1.1 EXECUTIVE SUMMARY.

This Heritage statement has been prepared by Granit Chartered Architects for Mr. Damian Thornton in May 2021 to support an application for Listed Building Consent. This report has been updated and extended following Pre-application Advice in March -April 2021, and takes on board comments and requests from the Council made both during the Pre-App meeting and the subsequent report. Pre-Application Advice summary and response on following pages.

Pre-App Reference Number: 21/EQ/0042

29 Champion Grove is a Grade II listed building, located in London Borough of Southwark Conservation Area. It comprises of a pair of semi-detached houses, No.27 and No.29 Champion Grove.

Proposed Lower Ground Floor Plan

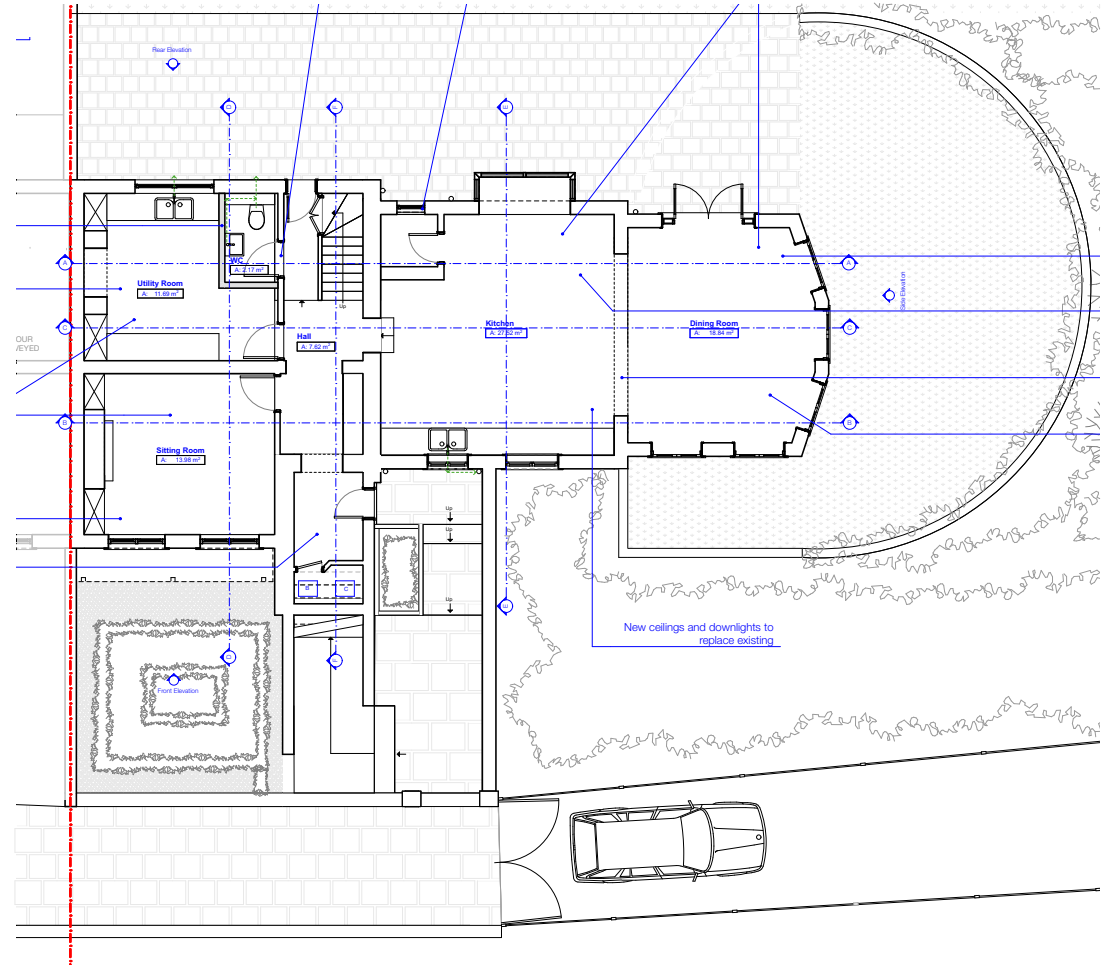
"The proposals require listed building consent, however the works to the chimney stacks are not supported without further information regarding historic fabric remaining behind modern plaster. This is required to ascertain the extent of chimney stacks at lower ground floor.

"I have now reviewed and can confirm with regards to the chimney stack it has been much altered and therefore doesn't relate well to the room – it could be removed with consent and the information sent regarding the strip out."

- Removing redundant and blocked-up chimney-breast and enlarging opening between Kitchen and Dining-Room (including replacing existing steel with new)
- Blocking-up small window from inside only (external elevation unaltered)
- Lowering Dining-Room floor to allow level access from Kitchen and installing new under-floor heating
- Relocating WC to rear Utility Room; separated by new lightweight-timber partition
- Creating new opening to WC access from Hall
- Installing under-floor heating throughout, floor levels to be relaid as existing
- Replacing existing ceilings and lighting with new
- Removing modern suspended ceiling to Dining-Room
- General refurbishment / decoration throughout.

The following pages were submitted and reviewed by the Planning Officer; who responded with the following comments in support of its removal. Email attached on page 23.

Extract of Existing LGF Plan [NTS]

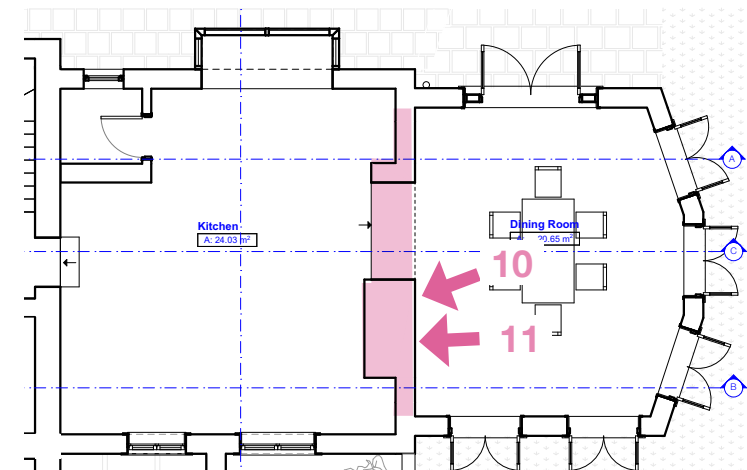
Some minor changes to the proposals are also recommended for the WC cloakroom at lower ground floor are also recommended as these elements may harm the significance of the grade II listed building.

The basement utility room cloakroom could also be accessed via the hallway as the wall in that location is also unlikely to be original. Please include the additional information with the application.

- Strip-out of the masonry structure revealed large areas of modern brickwork and cement-based mortar also to the back side of the chimney-structure.
- There are clear areas of modern infill that replace historic fabric, leaving little original fabric remaining.
- The small remains of historic fabric is in poor condition and has been largely damaged during the previous construction works that included the installation of a new concrete beam over.
- It is therefore consider to have been altered to such an extent that it no longer relates well to the room and no longer contributes to the historic significance of the property.
- This additional information has been reviewed by the council and the removal of this fabric is supported; please see attached email correspondence for details.

Right: Email correspondence from Planning Officer at Southwark Council to confirm receipt and review of the additional strip-out information, and agreement that little historic fabric remains and the removal of the Chimney-stack and creation of an opening into the Utility Cloakroom is considered acceptable.

11 Photo showing existing level difference between Kitchen and Dining-Room beyond. Proposals to dig-up Dining-Room slab and relay at lower level aligned with Kitchen FFL.

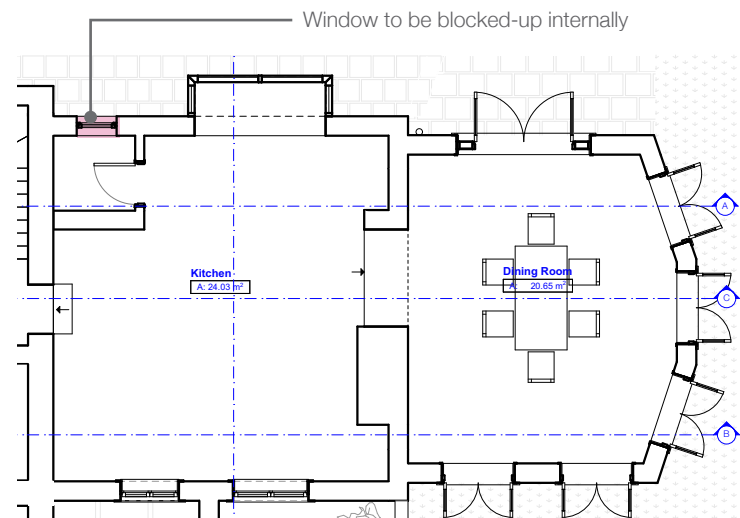
"This appears to be a modern 20th century floor and therefore would be acceptable."

Extract from Pre-App Report supports dropping of modern floor-slab to provide level access from Kitchen.

12 Photos of existing WC located at Lower Ground Floor, under the front entrance steps.

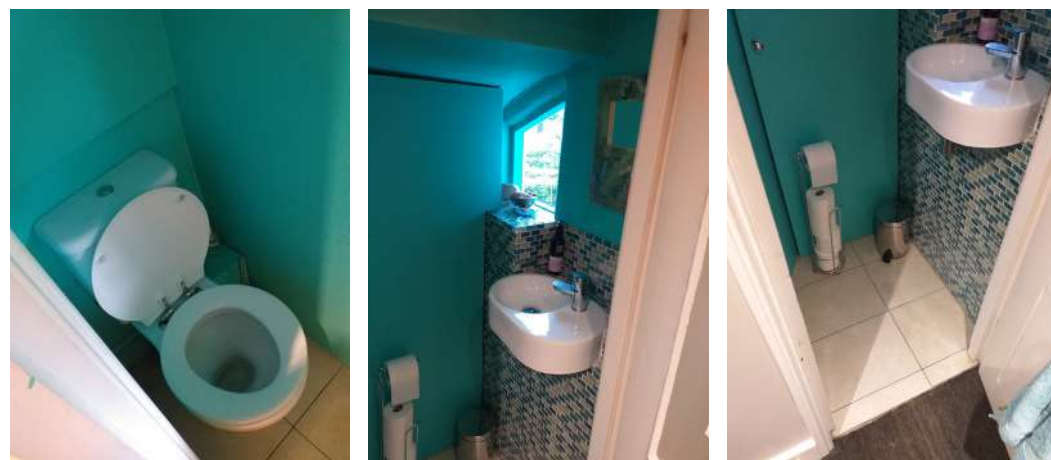
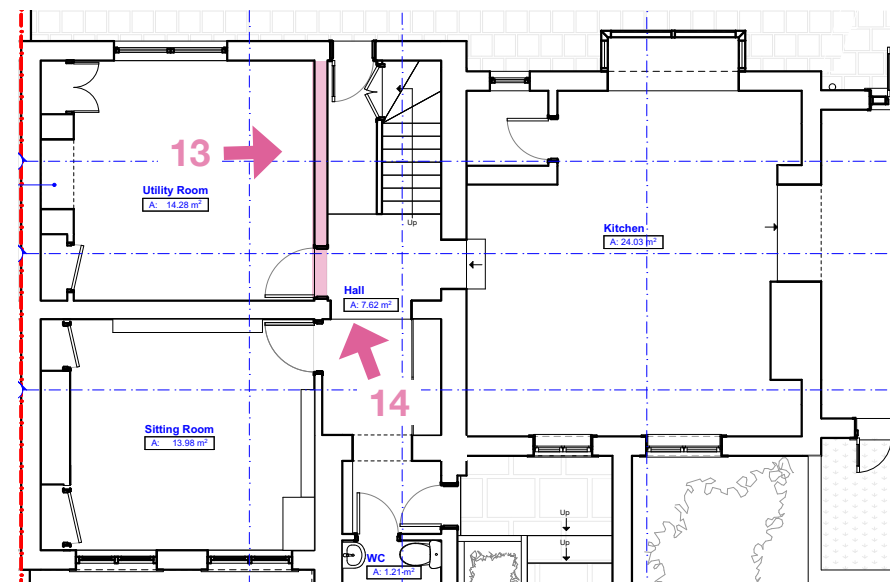
"The minor change to a secondary room could be tolerated within the significance of the building"

- Existing WC is the only one on this floor and it's size is considered inappropriate for modern living (both in width and head-height). It has also been clumsily sub-divided with a timber-boarding in order to conceal the services beyond.

- As no WC is original inside a Georgian dwelling, it is proposed that relocating the WC to a more appropriate size and location would benefit both the property and the occupants and is not considered to negatively impact the building's heritage value.

- The new stud partition enclosing the WC is proposed as lightweight timber stud that can ultimately be reversed at a later date to restore the original planform. As an alternative solution, this WC enclosure could be created out of in-built joinery to further remove any permanent alteration to the existing planform.

Extract from email correspondence with Planning Officer supports new door opening from Hallway to Utility cloakroom/WC.

Extract of Proposed Long Section C Plan [NTS]

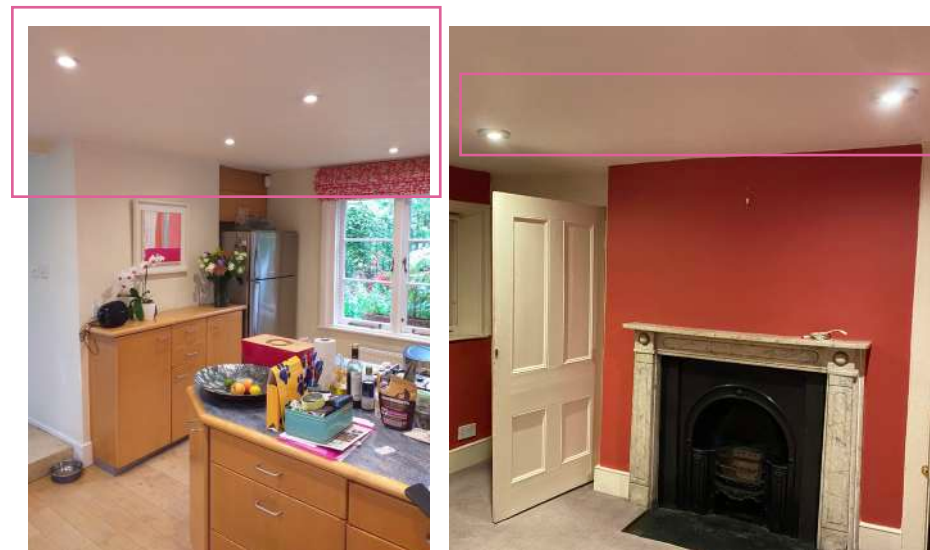
"Underfloor heating could be acceptable, subject to details of the impact on skirting boards – a section drawing at 1:5 or similar of proposed new flooring and relationship to skirting boards and other joinery where existing should be submitted as part of the application."

Extract from Pre-App Report supports installation of underfloor heating, provided detail sections are included (relevant sections attached as part of this application).

Proposed First Floor Plan

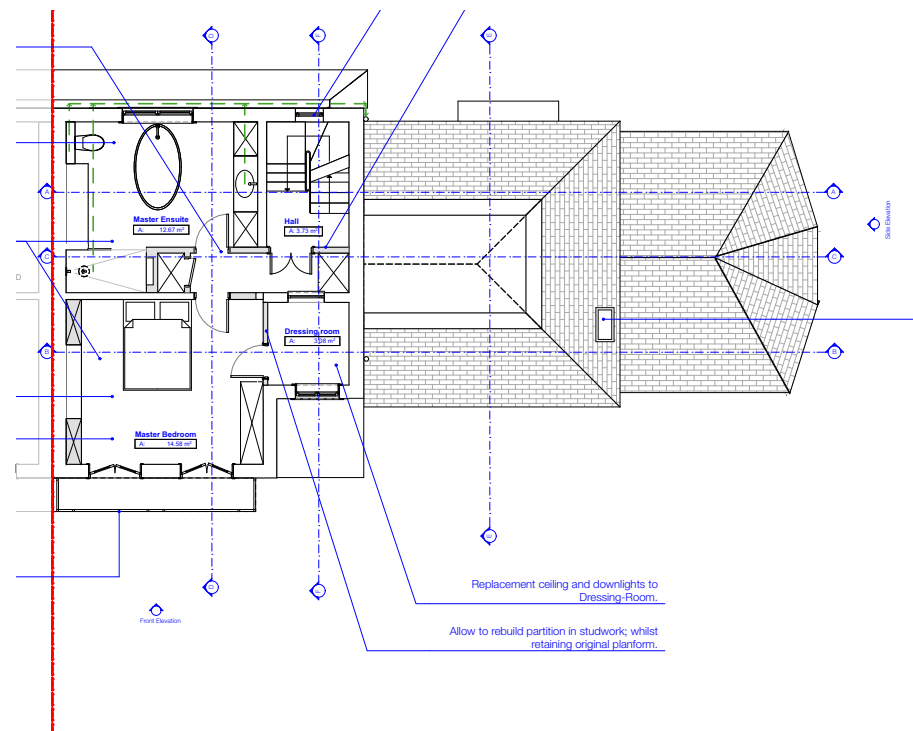
"The changes to the floor plan relating to the partial removal of a central spine wall at ground floor, the insertion of bathroom and stud walls at first floor, and the addition of new windows to the rear are not considered to cause harm to the significance of the listed building."

- Amending layout to include new lightweight timber partition & doors from stair
- Amending layout to create Ensuite to rear
- Amending existing doors to bedroom and Ensuite
